Product Change Notification

Change Notification #: 113399 - 00
Change Title: Intel® Server System R1304GL4DS9
PCN 113399-00
Product Design
Update the System Rear Panel, Add a Mylar
and a Plastic Block
Date of Publication: November 11, 2014

Figure One

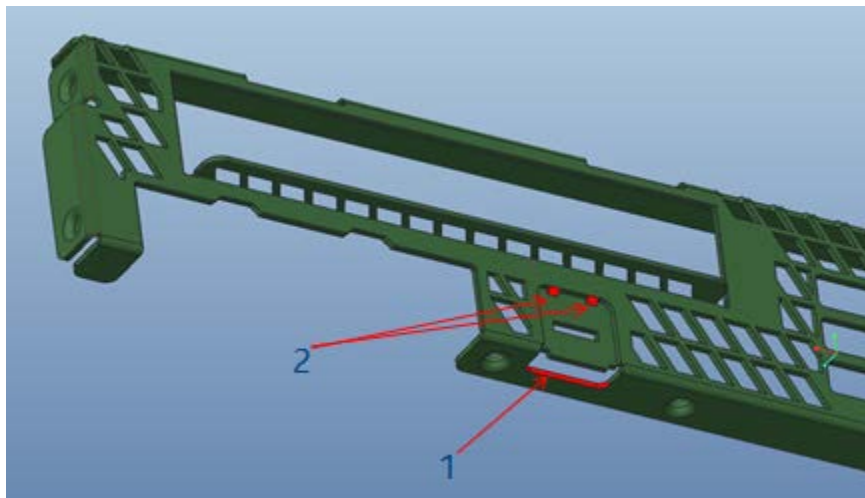
1. Add a connection at the bottom of the RMM4 (Remote Management Module 4) slot to improve structure strength. See item 1 in the Figure-1.
2. Update the one big center joint to two smaller joints so that the joints will not conflict with the LAN cable connector latch. See item 2 in the Figure-1.

Figure Three

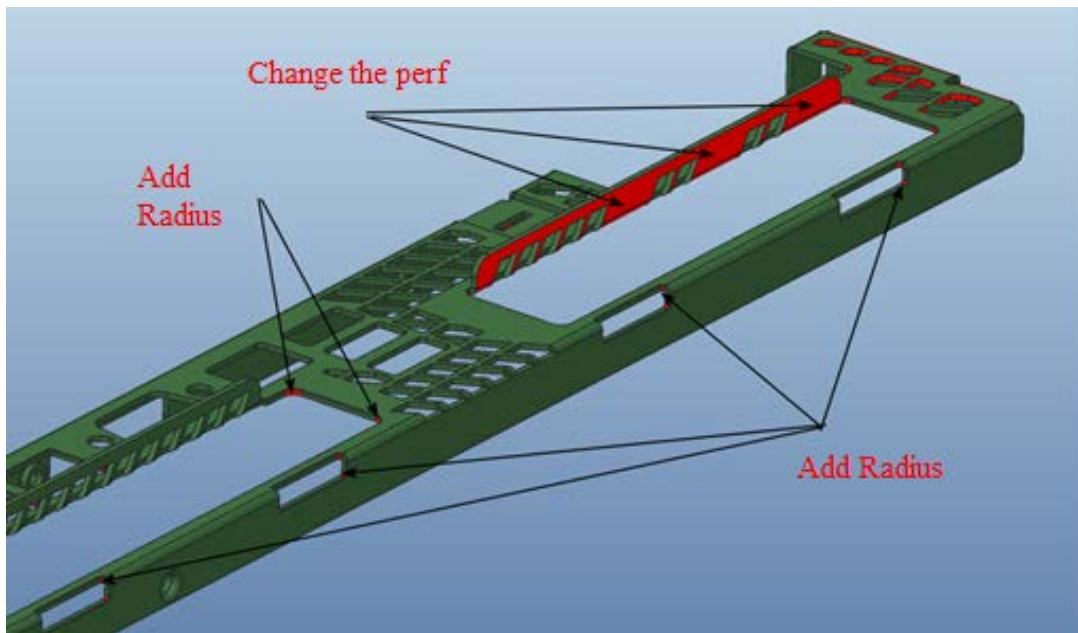
4. Update the perf and add radius to improve structure strength. See the Figure-3 and Figure-4.

Figure Five

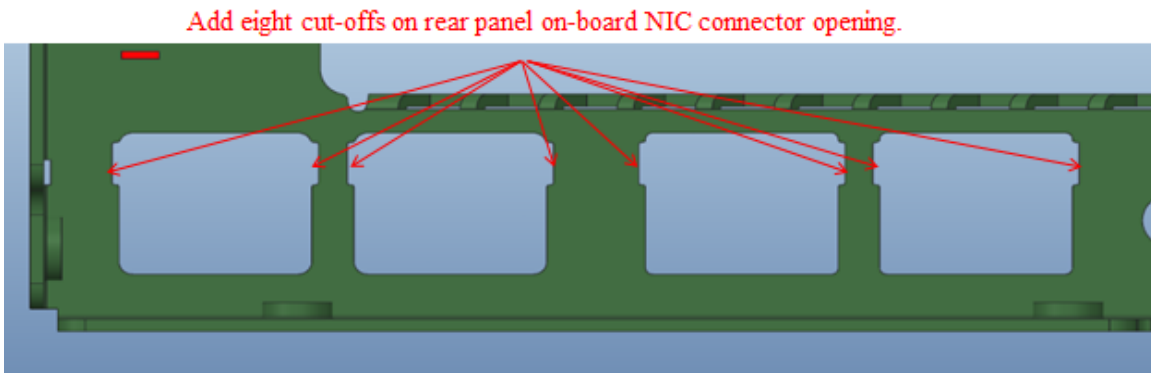
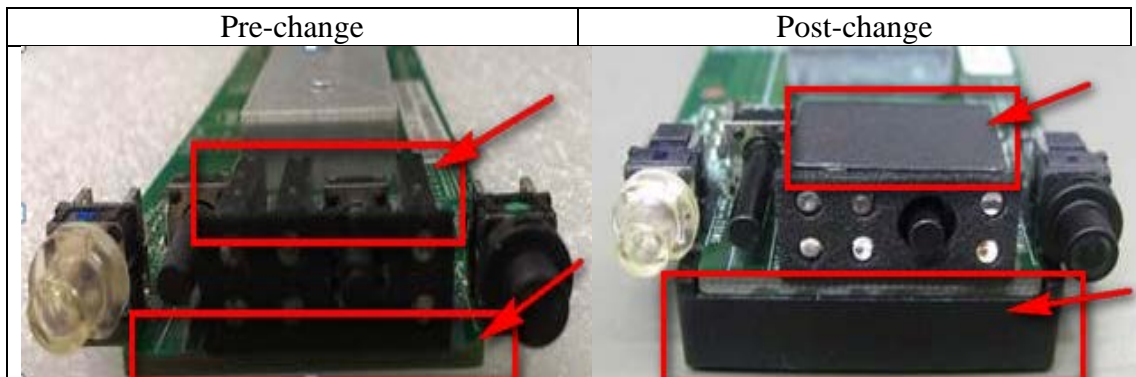
5. Add eight cut-offs around the on-board NIC (Network Interface Controller) openings to improve the LED visibility. See the Figure Five.
